MWO 9-1005-201-30-5

MODIFICATION WORK ORDER

**MODIFICATION OF MACHINE GUN, 5.56MM, M249
(NSN 1005-01-127-7510)**

21 May 1997

Figure 1.

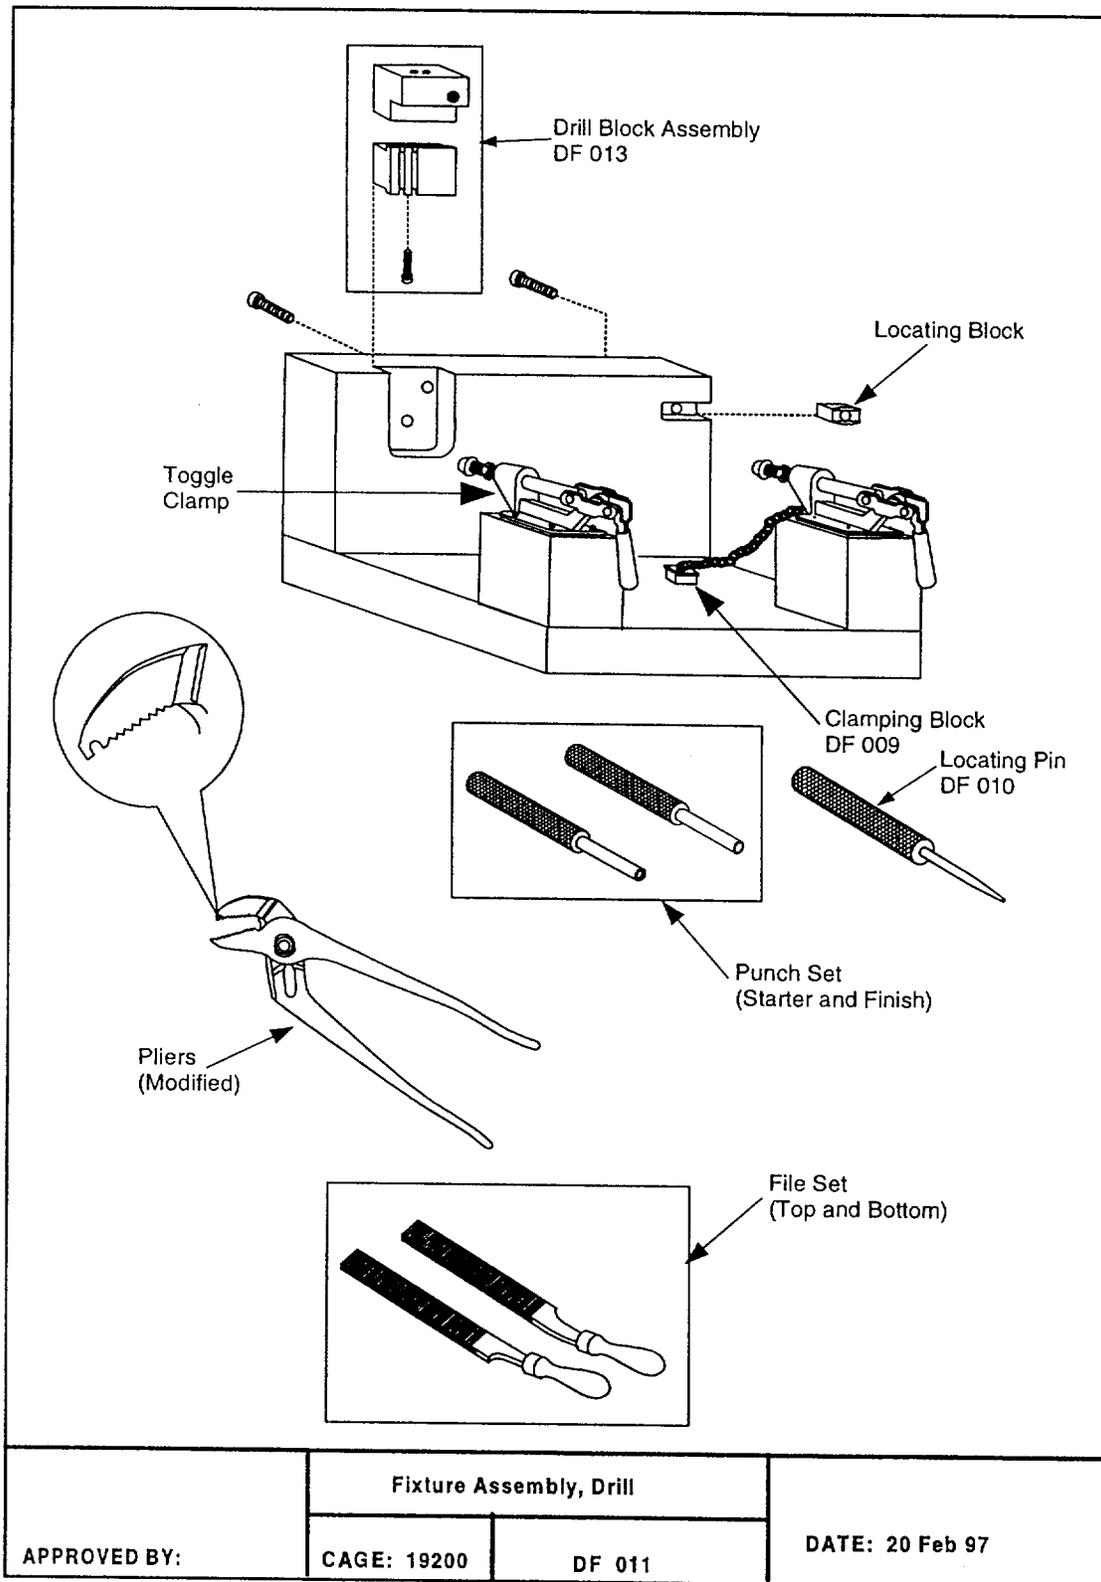
b. Special tools (furnished with modification kit drilling fixture, see Figure 1):

(1) Locating pin: tapered pin, part number DF 010, for centering prior to clamping, reaming, and drilling.

(2) Clamping block, part number DF 009.

d. Jigs (furnished with modification kit drilling fixture, see Figure 1):

(1) Drill block, assembly, part number DF 013, used for drilling and reaming operations.

(2) Locating block, used for locating and supporting the cocking handle channel during drilling and reaming operations.

(1) Drill Fixture (Fixture, Assembly, Drill, see figure 1), part number DF 011, NSN 1005-01-442-4811, provides capabilities of locating, clamping, reaming, and drilling receivers.
